Docket Item #12
BAR CASE# 2004-0111

BAR Meeting
July 21, 2004

ISSUE: Permit to Demolish

LOCATION: 420 Gibbon Street

Figure 4 Existing Rear Elevation

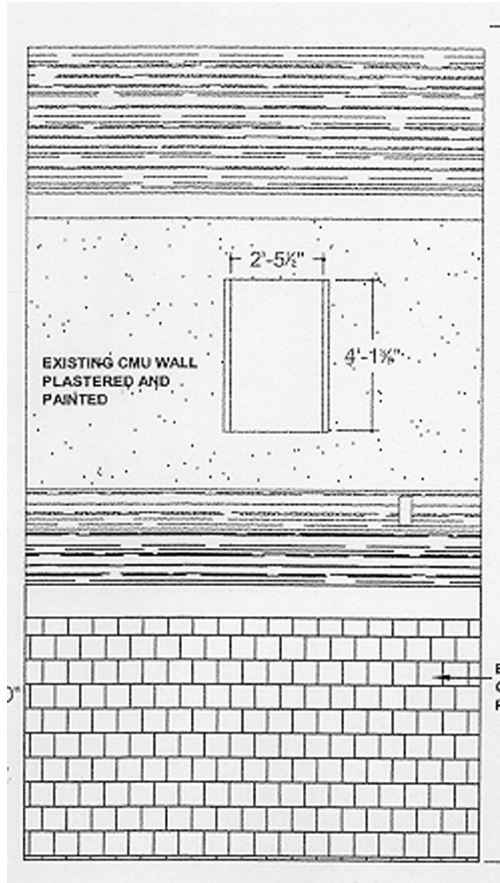
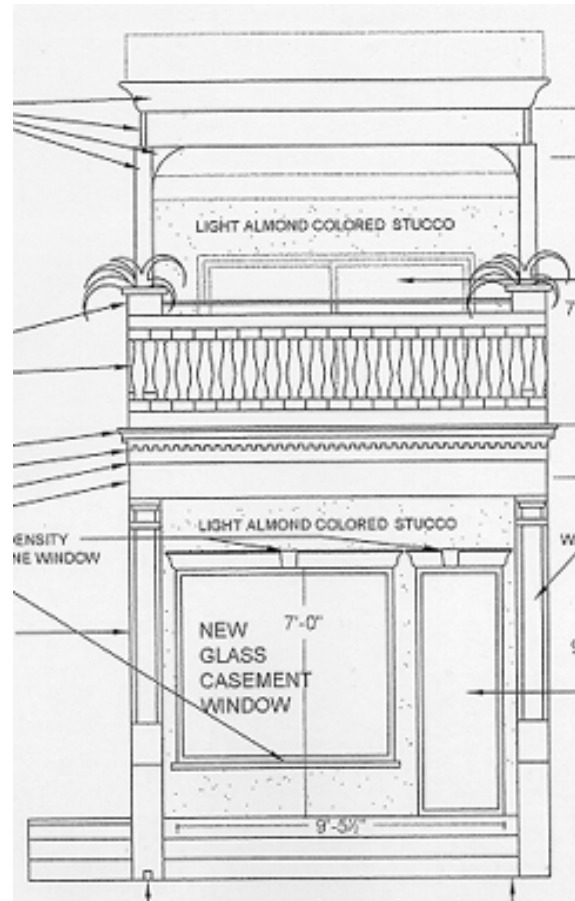
The applicant is also requesting approval to demolish/capsulate portions of the rear elevation of 420 Gibbon Street. The entire second story rear wall of the main block of the house will be encapsulated. In addition, approximately 53 square feet of the rear elevation of the one story addition will be demolished to accommodate a new casement window and door.
